Final Decision Document
for the Interim Response Action
for the Improvement of the North Boundary System
at Rocky Mountain Arsenal
Via Construction of Groundwater Recharge Trenches

RESPONSE TO US EPA REVIEW COMMENTS
ON PROPOSED DECISION DOCUMENT FOR
THE INTERIM RESPONSE ACTION FOR THE
IMPROVEMENT OF THE NORTH BOUNDARY SYSTEM
AT ROCKY MOUNTAIN ARSENAL VIA CONSTRUCTION
OF GROUNDWATER RECHARGE TRENCHES

STATE COMMENTS ON THE PROPOSED DECISION DOCUMENT FOR THE INTERIM
RESPONSE ACTION FOR THE NORTH BOUNDARY SYSTEM AT ROCKY MOUNTAIN
ARSENAL VIA CONSTRUCTION OF GROUNDWATER RECHARGE TRENCHES, APRIL,
1988

RESPONSE TO STATE OF COLORADO REVIEW
COMMENTS ON PROPOSED DECISION DOCUMENT FOR
THE INTERIM RESPONSE ACTION FOR THE
IMPROVEMENT OF THE NORTH BOUNDARY SYSTEM
AT ROCKY MOUNTAIN ARSENAL VIA CONSTRUCTION
OF GROUNDWATER RECHARGE TRENCHES

Figure 3. Generalized Alluvial Groundwater Flow Across RMA

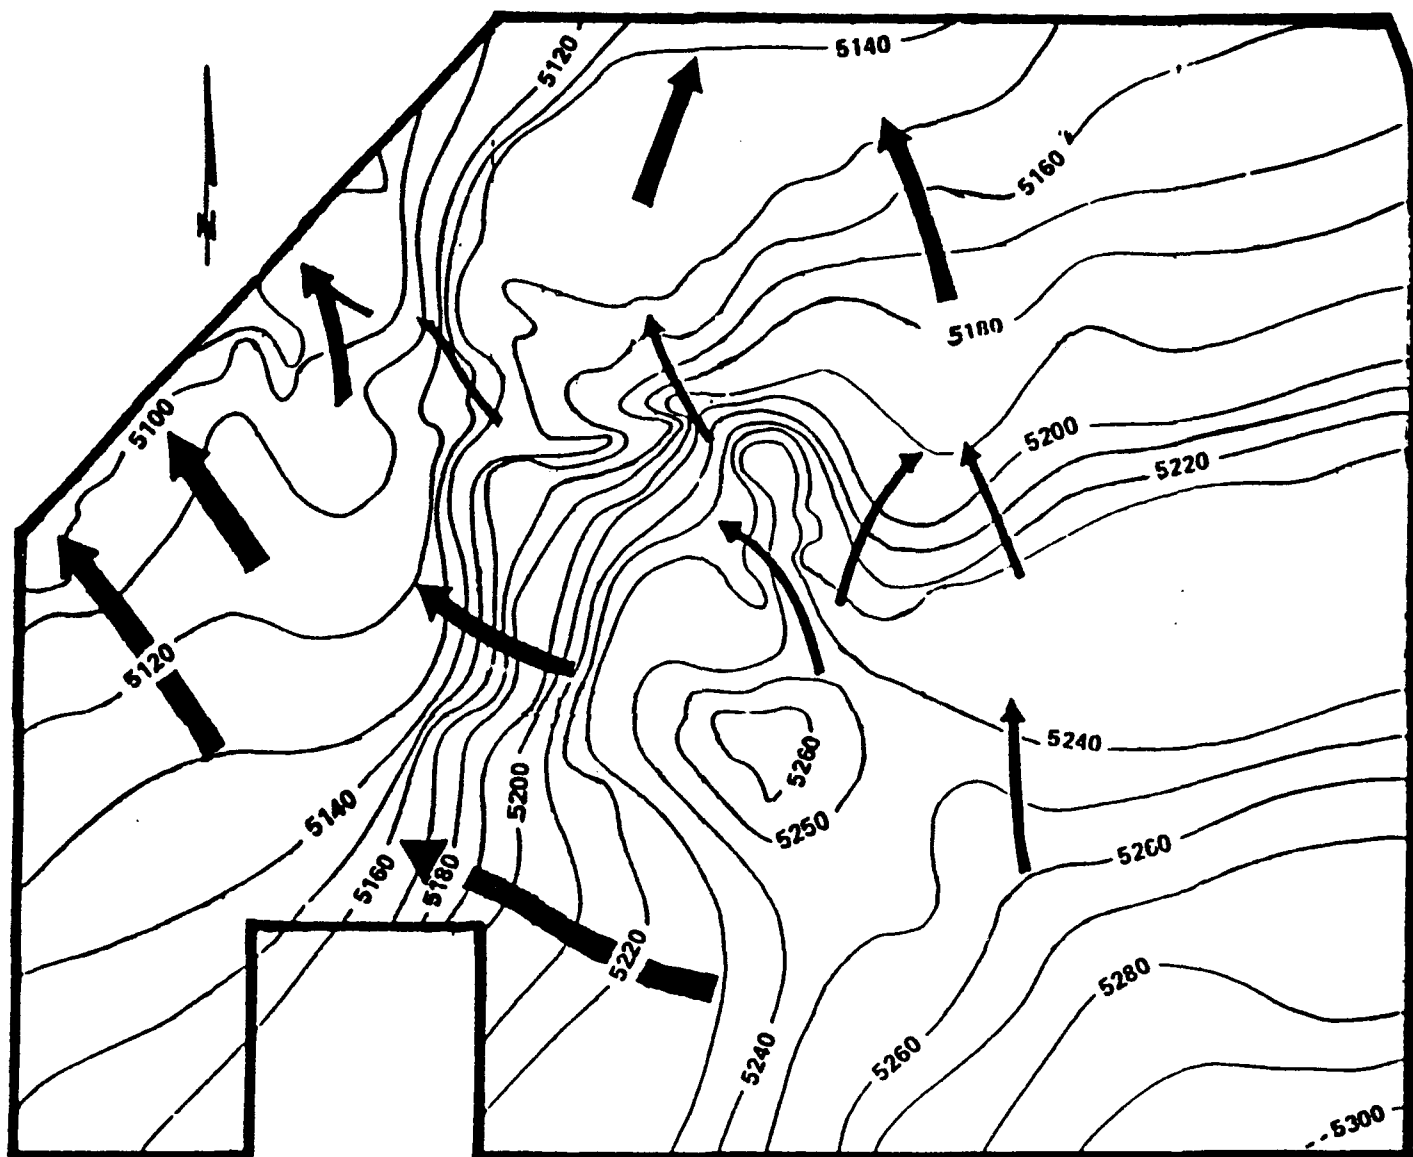
3. Pg. 2, para. 3. The second sentence should indicate that, generally alluvial groundwater beneath RMA flows from southeast to northwest and that Figure 3 represents generalized alluvial groundwater flow across RMA. Emphasis added.

4. Pg. 5, Figure 3. See Specific Comment ³/₅.

3. Page 2, paragraph 3. Emphasize text to clarify generality.

4. Page 5, paragraph 3. See specific comment 3.

Response: The text shall be modified as follows: "Alluvial groundwater beneath RMA generally flows from southeast to the northwest. Figure 3 represents the generalized alluvial groundwater flow across RMA."

Response: The description for Figure 3 shall be modified as follows: "Generalized Alluvial Groundwater Flow Across RMA."
